Assessment of the 2008 North Florida Numerical Groundwater Flow Model

Limitations & Implications for Groundwater Resource Management

January 21, 2014

Prepared for:

Figure 22 – NFM-08 – Ratio between Equivalent Model Transmissivity Values and Values Reported by the USGS

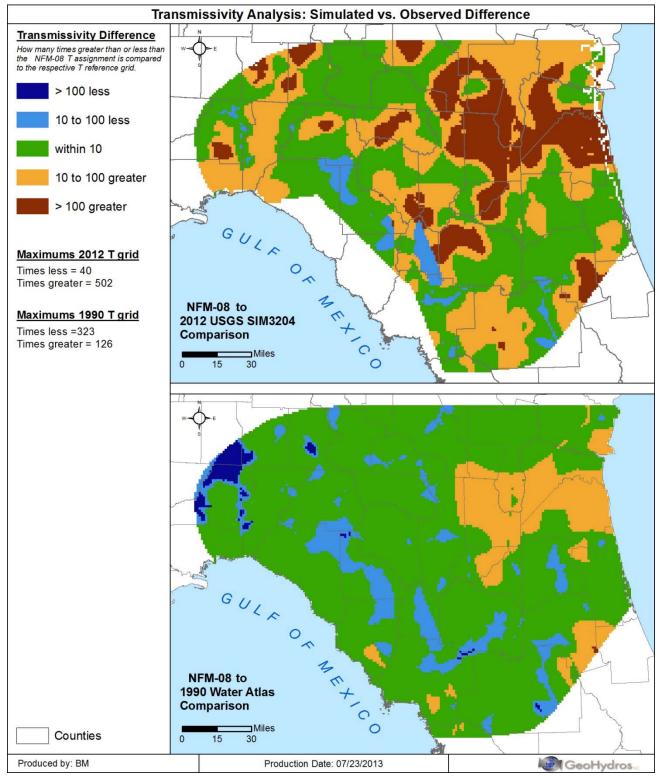
- the hydraulic conductivity values used differ from observed values by as much as 2.7 orders of magnitude (502 times; Figure 22);
- 2) the distribution of hydraulic conductivity values fails to correspond to well established hydrogeologic zonation (Figure 23);
- 3) the distribution of recharge values is arbitrary and does not correspond to hydrologic variables or land use (Figure 24 and Figure 29); and
- the magnitude of and variation in streambed conductance does not correspond to a reasonable conceptualization of the relationship between the UFA and the rivers in the unconfined portion of the aquifer (see Sections 5.1 and 5.2.2 above).

Difference between the NFM-08 equivalent transmissivity values and values reported by the USGS in 2012 (Top) and 1990 (Bottom) shown as the ratio between the SDII and USGS values (SDII/USGS). The SDII values differ from the 2012 USGS values by more than one order of magnitude over 56% of the comparable model domain, ~4% of which is marked by values lower by 1 or more orders of magnitude, 35% of which by values higher by 1-2 orders of magnitude, and 18% of which by values higher by 2 or more orders of magnitude. The SDII values differ from the 1990 USGS values by more than one order of the comparable model domain, ~2% of which is marked by values lower by 2 or more orders of the comparable model domain, ~2% of which is marked by values lower by 2 or more orders of magnitude. To rate orders of magnitude, ~9% of which by values lower by 1-2 orders of magnitude, and ~13% of which by values higher by 1 or more orders of magnitude.

Figure 23 – NFM-08 – Comparison of Equivalent Transmissivity Values to USGS 2012 Values Binned to Emphasize the Difference in Distribution

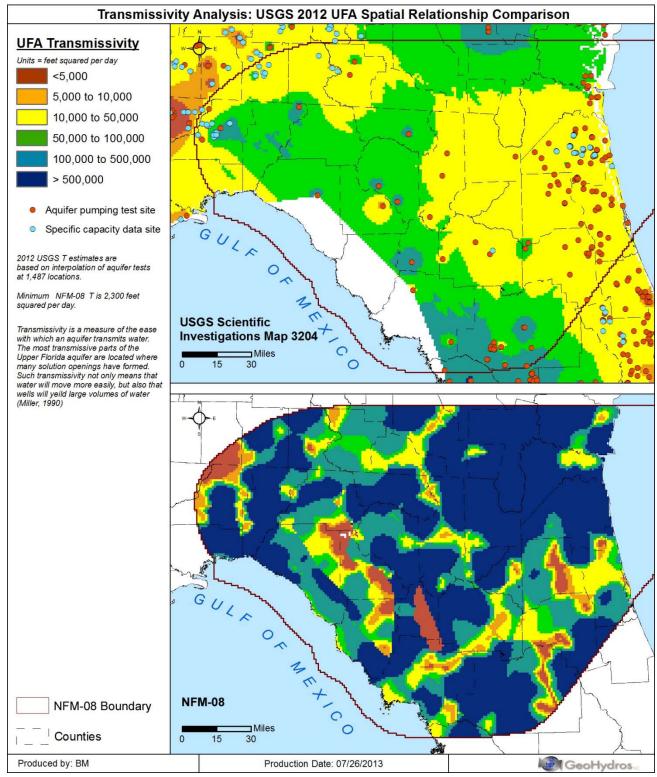
Figure 23 compares the NFM-08 equivalent transmissivity values to the 2012 USGS values where the distribution of values on both maps have been classified to show variation at a half order of magnitude scale in order to emphasize zonation. Comparison of the two maps at that scale clearly reveals that the distribution of the NFM-08 transmissivity values fails to correspond to the known hydrogeologic zonations in north Florida. This is likely a result of overly broad constraints placed on PEST during the model calibration and indicates that the SDII values are merely an artifact of model calibration designed to yield an expedient correlation between simulated and observed groundwater elevations. By example, much of the lower permeability zones defined in the NFM-08 correlate with the river corridors, which is contrary to what is known about the extensively karstified limestones along the rivers. The resulting model permeability framework cannot therefore be considered to be constrained by known and available data, nor reasonably represent well established and accepted Floridan aquifer characteristics.

The two maps compare transmissivity in the Upper Floridan Aquifer as defined by the USGS in 2012 (top) to equivalent values derived from hydraulic conductivities and aquifer thicknesses defined in the NFM-08 (bottom). The colors in both maps reflect values that have been binned to emphasize zonation. Comparison of the two maps clearly reveals that while the USGS map reflects well-established hydrogeologic zones (i.e. lower transmissivity in the confined part of the aquifer in the eastern half of the peninsula and in the Gulf Trough, and higher transmissivity in the unconfined part of the aquifer in the western part of the peninsula), the distribution of the NFM-08 transmissivity values fails to correspond to the known hydrogeologic zonations in north Florida.

Figure 29 – NFM-08 – Distribution of Correlations between Model-Assigned Recharge and Measured Precipitation and Ground Surface Slope.

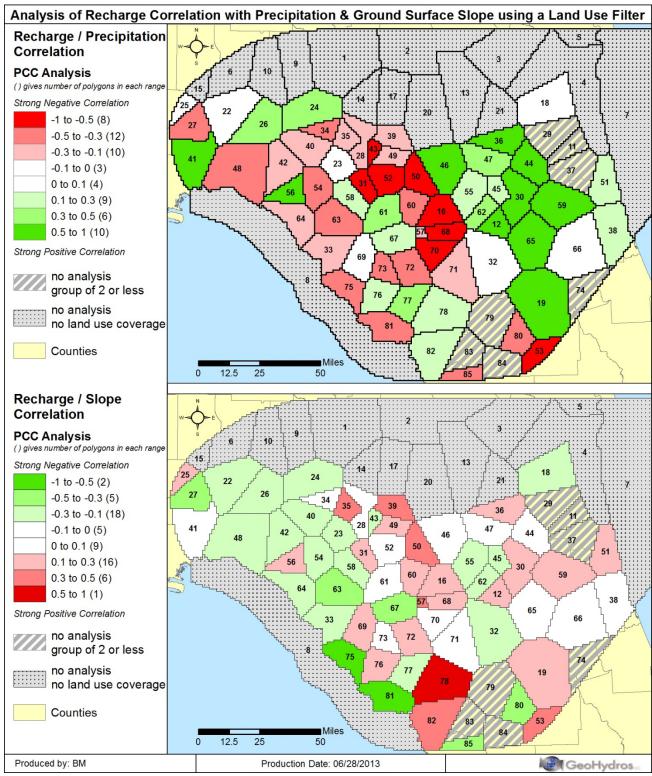
The results of the correlation analyses relative to land use are depicted in Figure 29. Nineteen (19) of the 85 Thiessen polygons were omitted from the correlation analyses due to a lack of land use coverage or the absence of a correlation in dominant land use type to other polygons. Of the 66 polygons that were included in the correlation analyses, only 10 display a correlation to measured precipitation that meets the expectation and only 2 display a correlation to ground surface slope that meets the expectation. The 10 polygons meeting the expected correlation to precipitation were predominantly located in the eastern part of the model domain where the UFA is confined. None were located in the central part of the domain in the Suwannee River basin. The 2 polygons meeting the expected correlation to ground surface slope were both located in the southwestern part of the model domain along the Gulf of Mexico coast.

- substantial discrepancies between the modeled distribution of recharge and distributions that can be supported by the spatial variation in precipitation or documented land use (Figure 29);

(Top) Distribution of Pearson Correlation Coefficients describing the relationship between model-assigned recharge and measured precipitation in groups of the Theissen polygons used to assign recharge in the NFM-08 having statistically similar land use where the expectation is a positive correlation with a PCC value of between 0.5 and 1.0. (Bottom) Distribution of PCC values describing the relationship between model-assigned recharge and measured ground surface slope in the same groups where the expectation is a negative correlation with a PCC value of between -0.5 and -1.0. In both maps, the polygons in which the correlation meets the expectation are colored bright green and the red polygons mark those where the relationship is the opposite of the expectation.

Figure 31 – NFM-08 – Difference between Assigned Recharge and Recharge Constrained by Basin Discharge

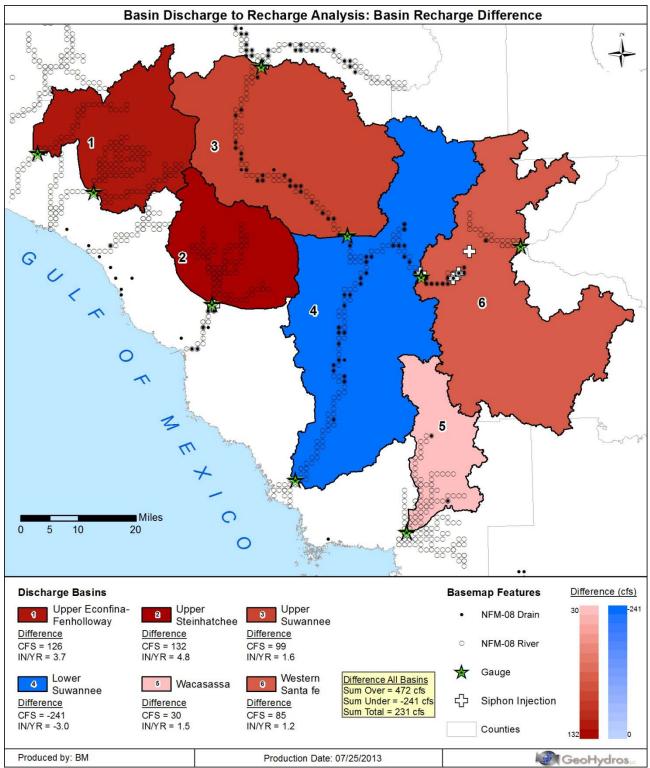
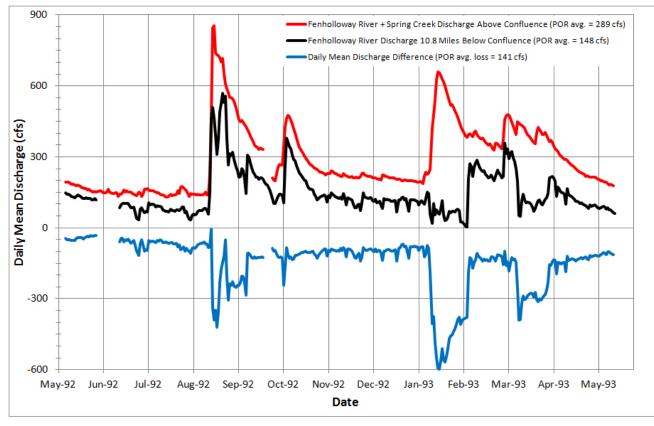
The results are shown in Figure 31 and Table 8 where they are reported in terms of in/yr and cfs per basin. The result of the comparison shows that the NFM-08 over-estimates recharge into 5 of the 6 basins by a total of 472 cfs and under estimates 1 of the 6 by a total of 241 cfs for a total difference of +231 cfs. The largest discrepancies occur in the coastal basins where the NFM-08 prescribes 1.6 times as much inflow to the Upper Steinhatchee basin than discharges to the river and 1.5 times as much as discharges to the Upper Econfina-Fenholloway. The discrepancies are less in the central part of the domain but the prescribed inflows are still more than the measured river gain to the Upper Suwannee River by 1.2 times.

- substantial discrepancies between the magnitude of modeled recharge and the magnitude that can be supported by available stream flow data (Figure 31); and

Figure 33 – NFM-08 – Comparison of Simulated Groundwater Flow Paths through the UFA to River Basin Boundaries

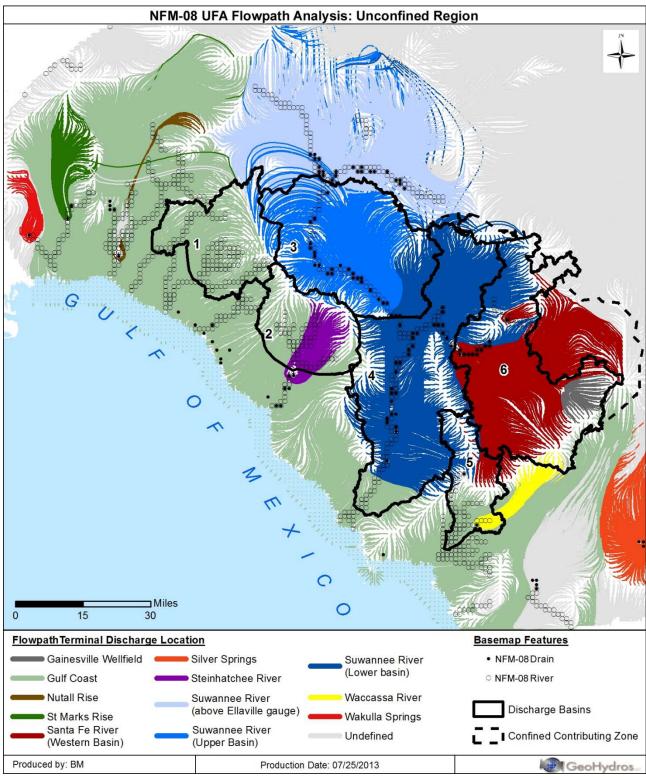
Figure 33 shows groundwater flow paths simulated by the NFM-08 relative to the river basin boundaries. Analysis of the simulated flow paths reveals that, while flow to the Suwannee and Santa Fe Rivers is fairly well constrained within the river basins, almost all of the simulated flow through the Econfina, Fenholloway, Steinhatchee, and Wacasassa basins is to the Gulf of Mexico coast rather than to the rivers. None of the simulated flow terminates at Econfina or Fenholloway river nodes. Because of this, the model is not capable of simulating impacts to the rivers due to pumping (as per say from the hypothetical expansion groundwater pumping for the City of Perry) because most of the simulated flow is to the coast.

The depicted groundwater flow patterns were created by executing forward particle tracks from the grid cells in the NFM-08. Flow patterns are colored to match the basin in which the model indicates groundwater will terminally discharge. Flow is from the basin boundaries to the rivers. The gray areas depict flow to locations that were not evaluated. The light green colors depict flow lines that pass the rivers and terminally discharge directly to the Gulf of Mexico. Some of the flow in these areas along the depicted particle tracks discharges at the river and drain assignments but the flow lines all terminate at the constant head boundary assignments along the coast. The fact that so many of the flow lines pass through the basins to the coast while the model calibrates to observed upstream river gains indicates that substantially more recharge was assigned in the model than can be accounted for by observable river gains.

Figure 35 – NFM-08 – Distribution of Simulated Specific Velocities & Calculated Reynolds Numbers

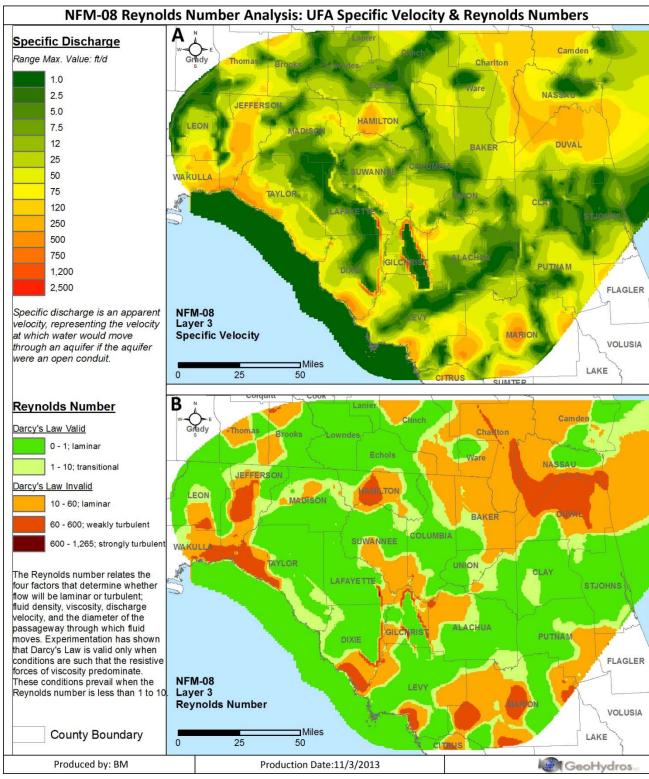
The groundwater flow equations used by the resulting model are valid only for porous media systems through which groundwater moves according to the diffuse flow assumption. As can be seen from Figure 35, the parameter settings used to calibrate the NFM-08 resulted in flow conditions that violate this assumption throughout close to half of the model domain. The lack of disclosure and discussion of the diffuse flow assumption therefore portrays veracity and reliability that cannot be supported by the mathematics on which the model was constructed.

- a substantial portion of the model domain in which the modeled configuration of aquifer parameters results in simulated flow conditions that violate the assumptions underpinning the groundwater flow equations on which the model was constructed (Figure 35).
